PORTLAND MAINE

RE: Peaks Island – John S. Bunton Properties – IR-1 with City water
89-A-1 & 4 – “Rockrest”
89-A-5 – “Camelot”
89-C-3 – undeveloped
89-C-4, 6 & 7 - undeveloped
89-C-5 - undeveloped
89-D-8 – undeveloped

RE: Request for Zoning Determination

Marge Schmuckal - Bunton Estate property - Tolman Heights, Peaks Island

Exhibit B

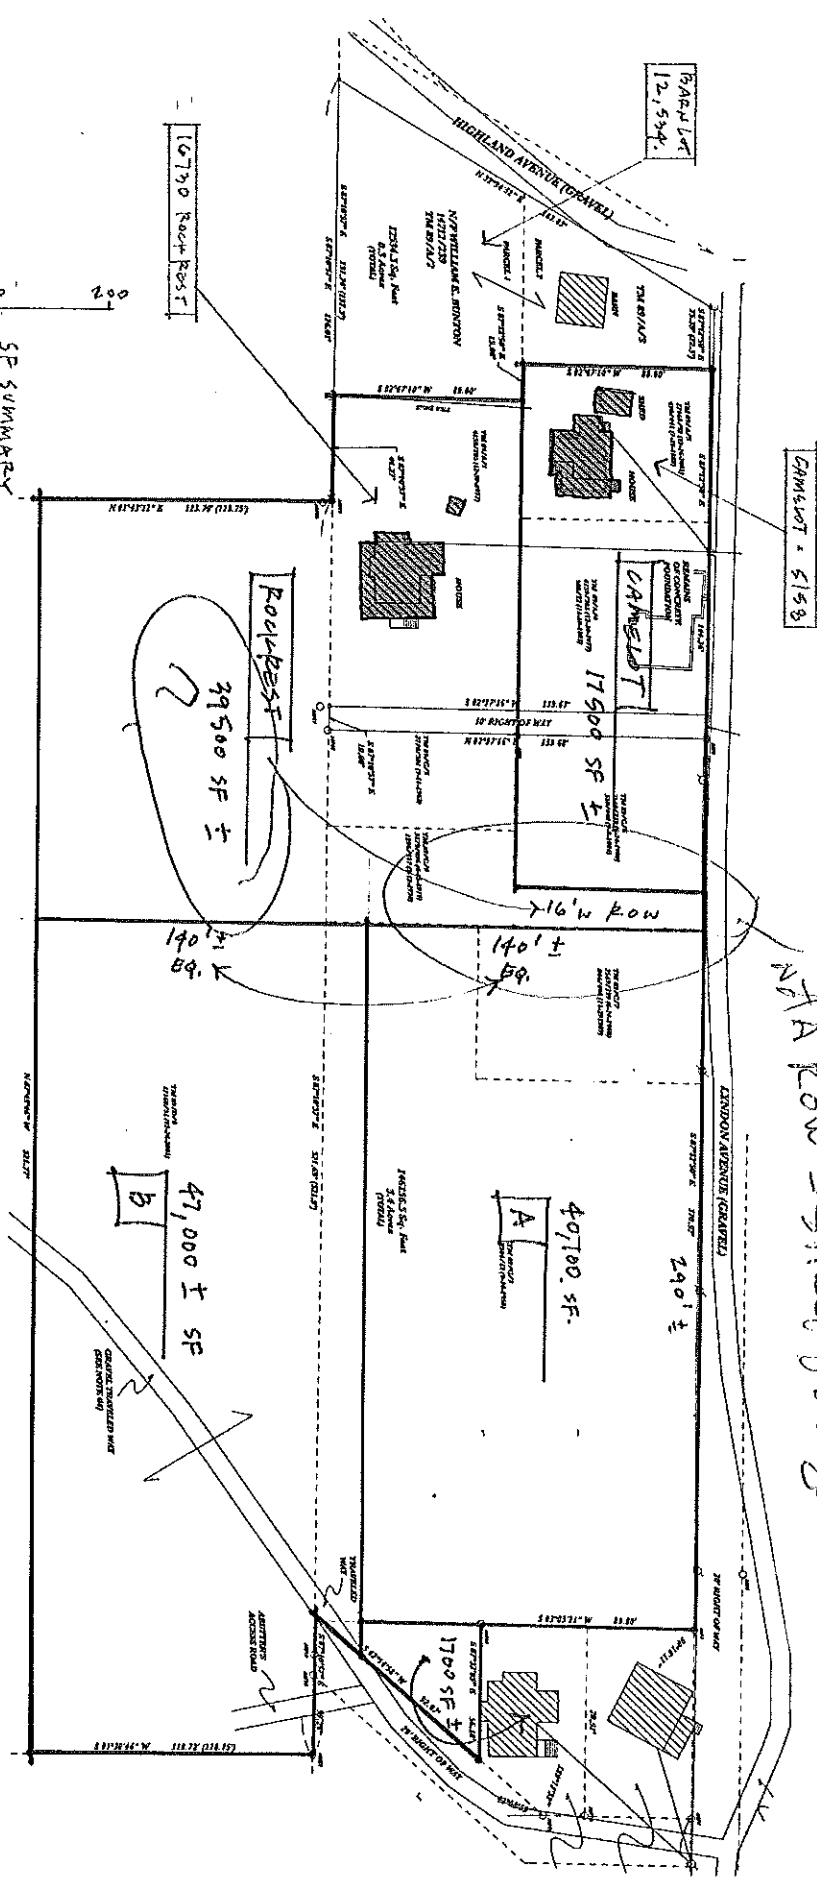
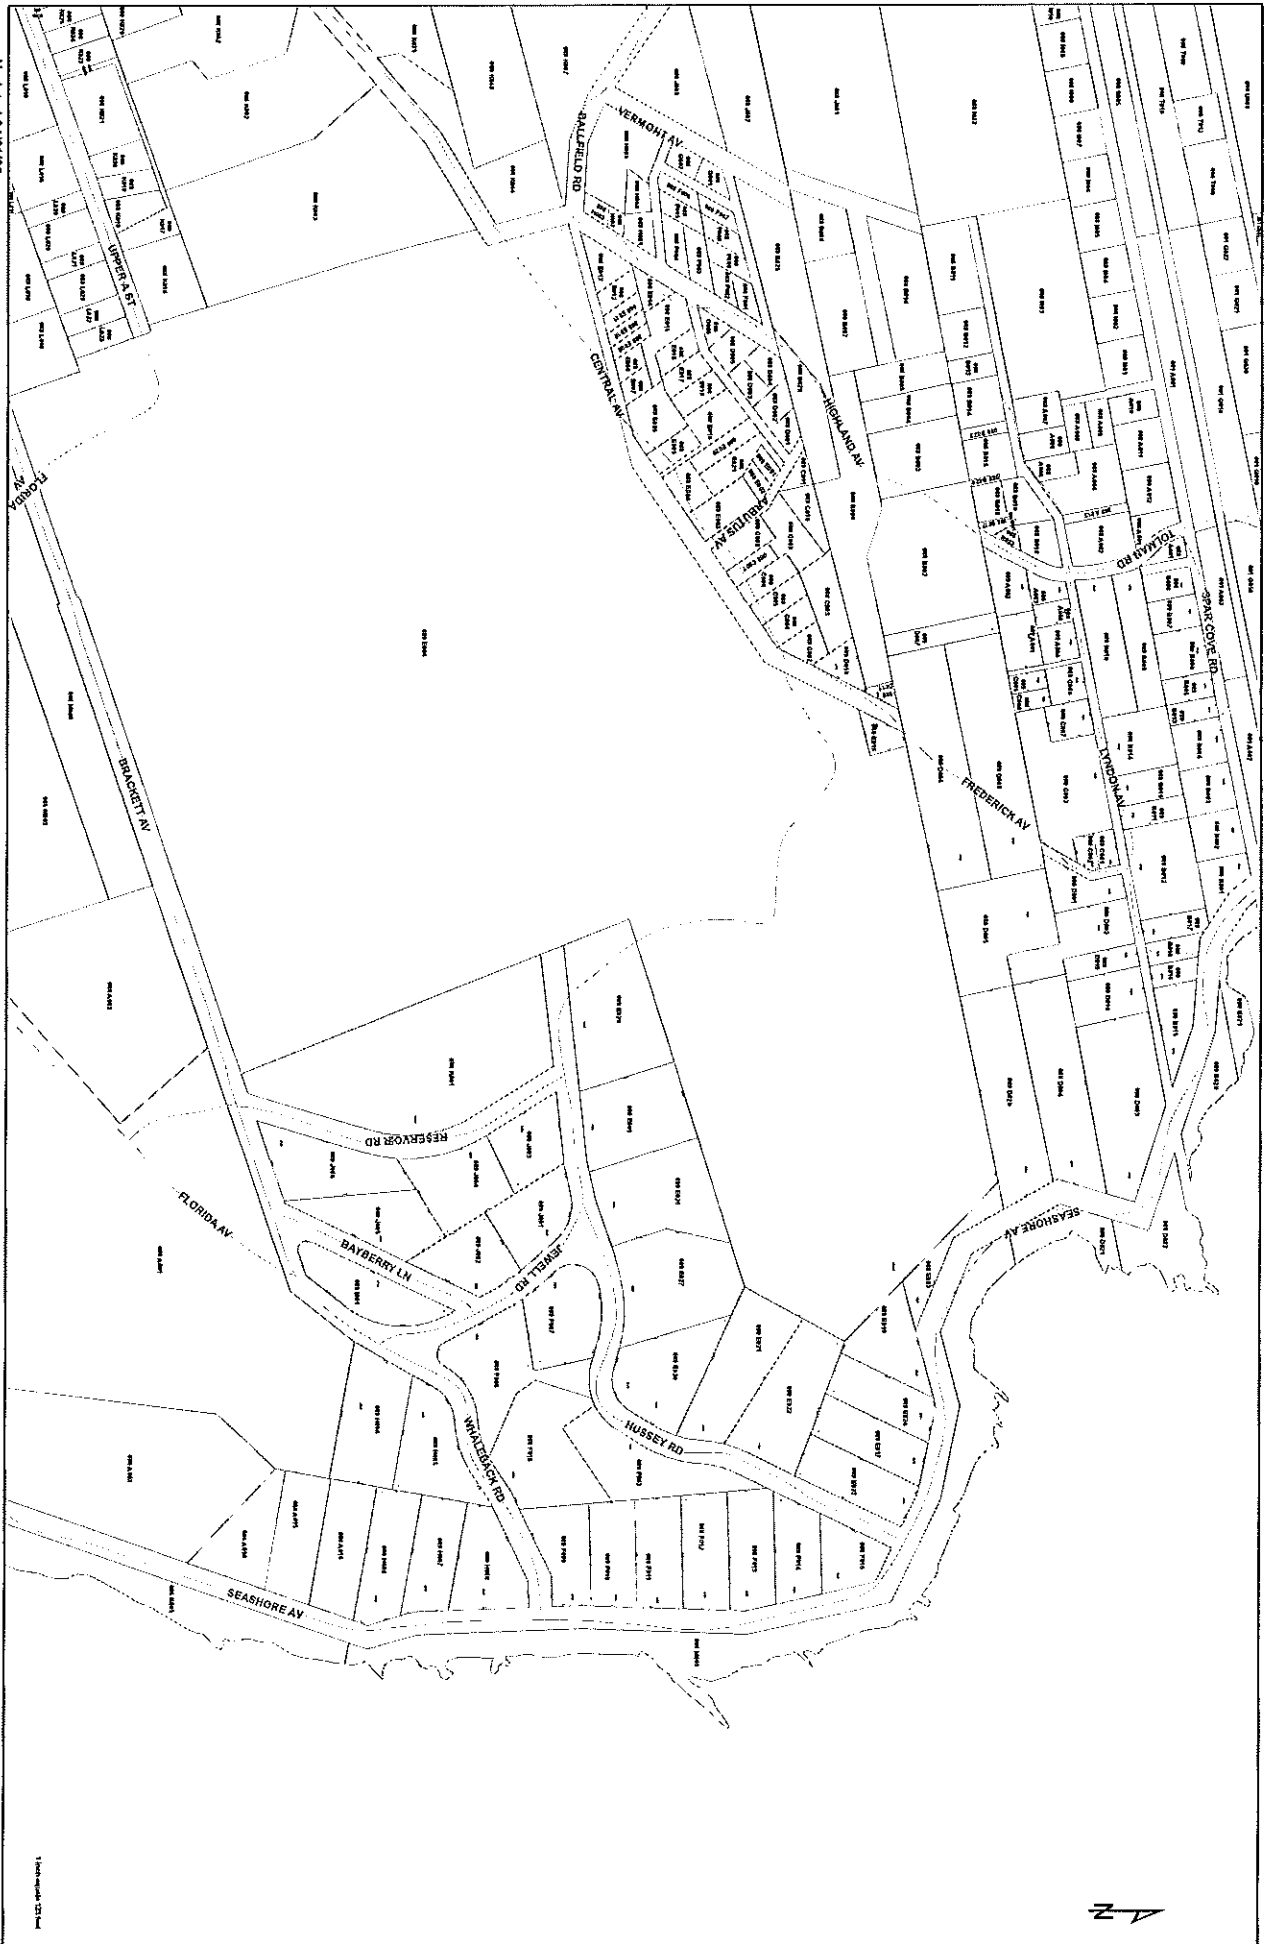
The determination the Buntons are asking you to make is that this configuration would be permissible under the zoning code. We believe it renders the existing grandfathered non-conforming parcels (Rockrest and Camelot) more conforming as to both size and frontage and also creates two fully conforming unimproved lots (marked "A" and "B" on Exhibit B) as to both size and frontage.

We believe the configuration shown on Exhibit B satisfies Section 14-145.5 (d), which says lots of record as described in Section 14-433 (a definition clearly met by Rockrest) need not have street frontage if access is available by means of a permanent easement or right of way with a minimum width of 16 feet and a minimum travel width of 8 feet. As you can see from Exhibit B, the easement the Buntons propose to create in a more easterly location will be 16' wide. It will provide access to an existing single-family dwelling on a lot that will be expanded in size from 16,000 to 39,500 SF.

Under the new configuration, the size of the Camelot parcel will increase to 17,500 SF and its frontage will increase as well, putting it over the 100' required in the zone.

Excepting the 1,700 SF triangle on the easterly end of the parcel,³ the remaining land will be divided into two lots, both larger than the 40,000 SF required for lots with public water

in the IR-1 zone. *See* 14-145-5 (a). Lot A has adequate frontage on Lyndon Avenue; Lot B would have its frontage on Frederick Avenue, which bisects it.

Based upon all the submitted information, I have determined that the reconfiguration shown on the revised sketch that I received on August 8, 2012, is not in violation of the Land Use Zoning Ordinance. The reconfigured lot for “Camelot” was enlarged and is legally nonconforming for the minimum lot size. The reconfigured lot for “Rockrest” is meeting the minimum lot size for the IR-1 zone. The other two vacant lots called “A” and “B” are meeting the minimum lot size requirement of 40,000 square feet. The somewhat triangular portion deeded to an adjoining developed lot does not jeopardize the reconfiguration and enhances the lot size of the adjoining lot.

I have also reviewed the 16' right-of-way and consider such right-of-way to meet the requirements of section 14-145.5(b) for the “Rockrest” lot.

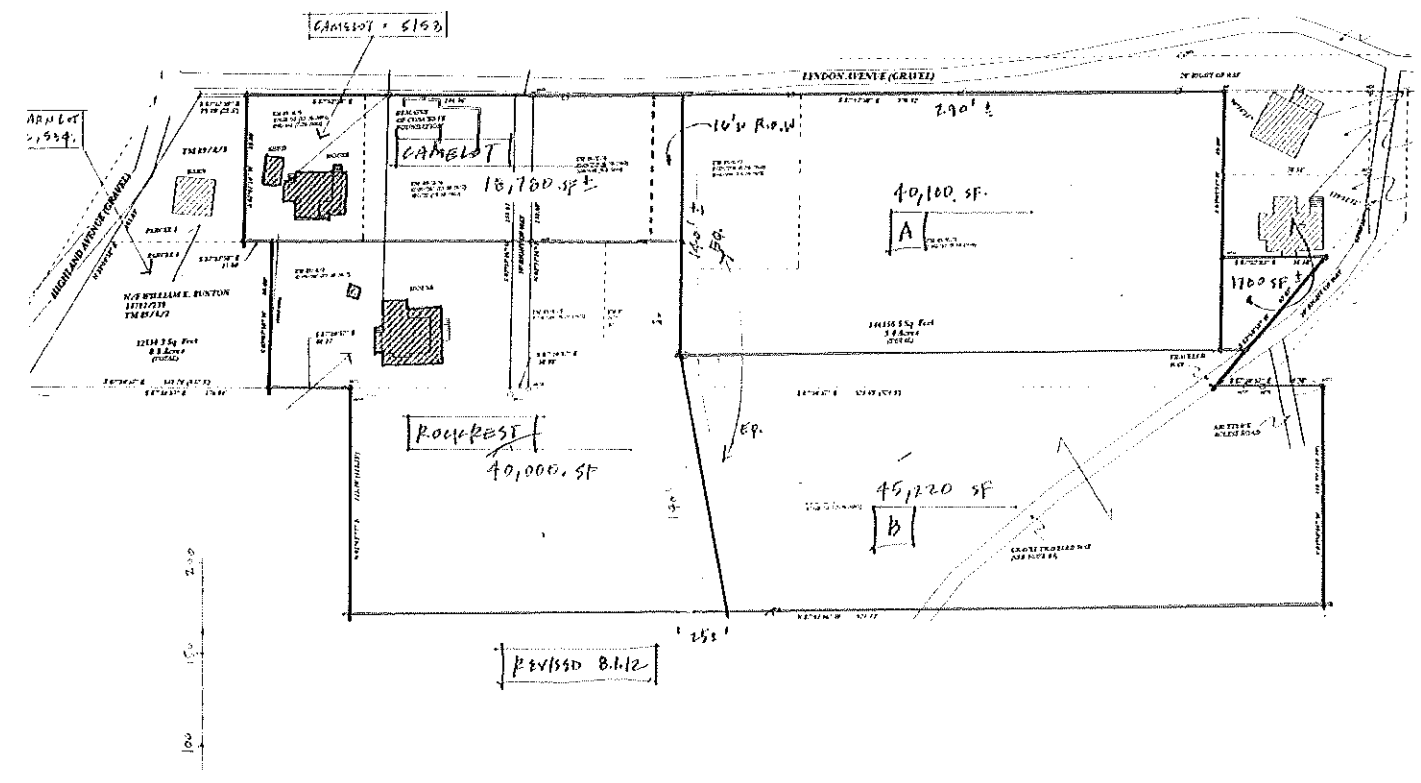
This sketch increases the size of the Rockrest parcel from 39,500 sf to 40,000 sf. This was accomplished by moving the easterly line toward the shore, at an angle. As compared to the initial sketch, this reduces the size of Lot B on the Plan to 45,220 sf, rather than 47,000, but that still is well more than the minimum required in the zone.

This revision will result in three of the four parcels meeting or exceeding the 40,000 sf minimum lot size, and the existing non-conforming as to size parcel (Camelot) increasing in size from 5,158 sf to 18,780 sf.

The drawing I submitted to you on July 3 showed the 16' strip as part of Rockrest. As we discussed, the frontage requirement in 14-145.5(d) talks in terms of a right-of-way, not panhandle access. This revised drawing shows a 16' right-of-way passing over the Camelot parcel. As compared to the initial sketch, this version increases the size of the Camelot parcel from 17,500 sf to 18,780 sf by adding the 1280 sf (16 x 80) that will be encumbered by the right-of-way. The adjustment in the easterly line of Rockrest adds a total of 1,780 sf to account for the 1,280 sf under the right of way previously calculated as part of Rockrest and the 500 sf it was short on the first configuration.

Please note that this new sketch also makes it clear the 1,700 sf triangle on the SE side of Lot A will be conveyed out to the abutters at the time these lots are divided up. It is of no practical use to leave it as part of Lot A and it will increase the size of the abutters' parcel.

final sketch
meeting I Per 1 mm,
lot sizes

16730 Rock Rest

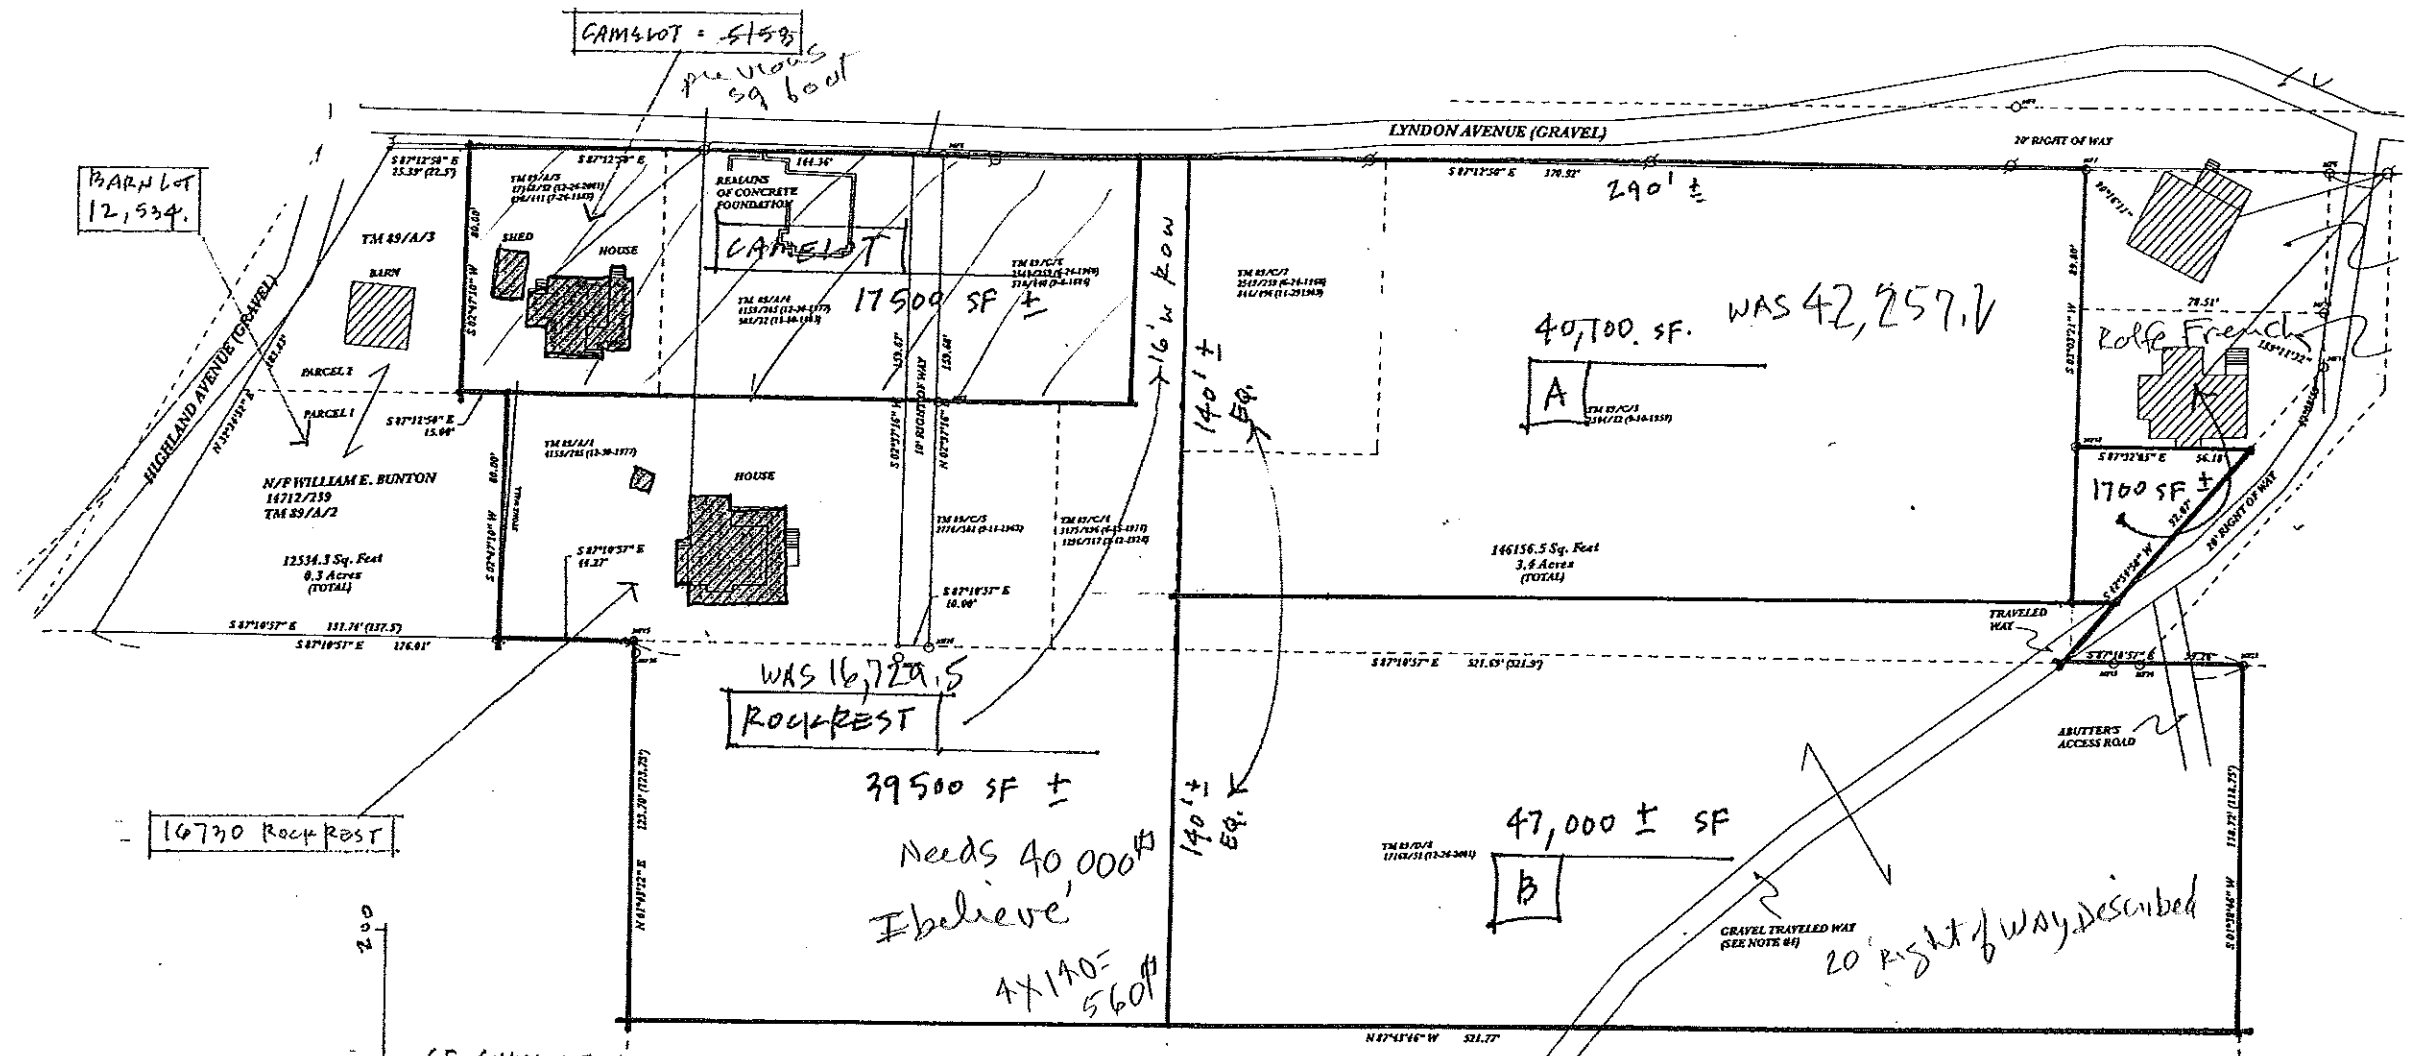
WAS 16,729.5
 ROCK REST

39500 SF ±
 Needs 40,000 sq ft
 I believe
 4x140 = 560 sq ft

47,000 ± SF
